1
2 UNITED STATES OF AMERICA
3 ATOMIC ENERGY COMMISSION

6 CONSOLIDATED EDISON COMPANY OF NEW YORK, : Docket No.
7 INC.

9 (Indian Point Station, Unit No. 2

12 Tuesday, July 13, 1971

REACTOR PIT CRUCIBLE
FIG. 7-1

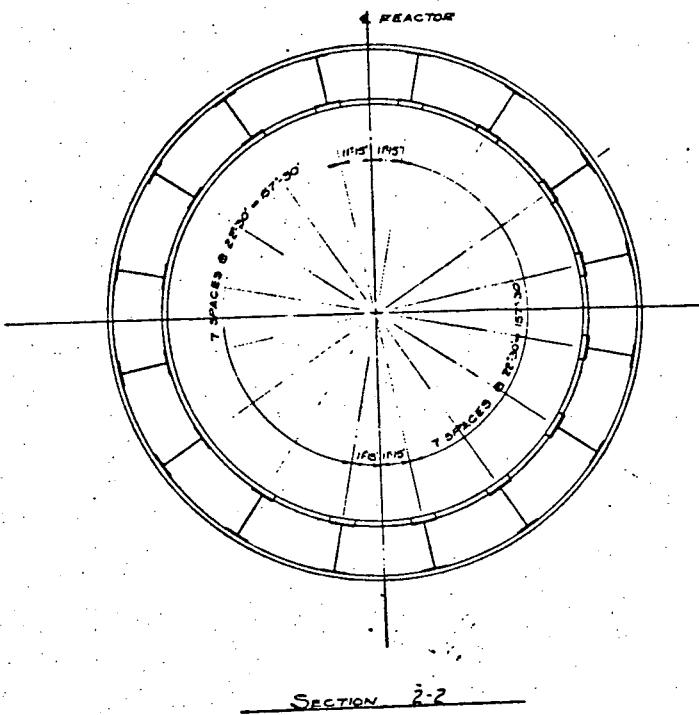
In addition to that the Applicant was going to provide and the papers seemed to indicate that it would be nice to provide for containment, at least, in the event this emergency core cooling system or one that was supposed to fail actually did fail and this was the reason for putting the crucible below the reactor vessel.

This was no longer considered necessary. In other words, no back-up for the emergency core cooling system seems to be considered necessary. Though there may be very good reasons for this, I think it would be desirable to discuss at the hearing more about what work was done on the design of that core catcher, I will call it, because this is stated in reply to the extensive design work that was done.

The reasons for elimination of the crucible are discussed in response to ASLB Question-3 (B) (TR. 683). The work done on the crucible prior to its elimination was in the areas of layout, structure, heat transfer and materials selection and mat

The reactor pit crucible was proposed in Supplement 5 to serve as back-up to the emergency core cooling system in the event that the core might melt and deposit in the reactor vessel cavity. The reactor pit crucible, Figure 7-1, is a refractory lined vessel with a sloped bottom supported and elevated from the cavity floor by structural members which allow free flow of water beneath the vessel and steam separation by way of the space between the vessel sides and the concrete reactor cavity walls. The crucible is located directly below the reactor vessel and in-core instrumentation guide thimbles, and extends into the access tunnel as shown on Figure 7-2. The capacity of the crucible is sufficient to contain all of the fuel (UO_2), fuel assembly grids (Inconel), fuel assembly end fixtures (stainless steel) and portions of the lower core support structure and reactor vessel bottom head.
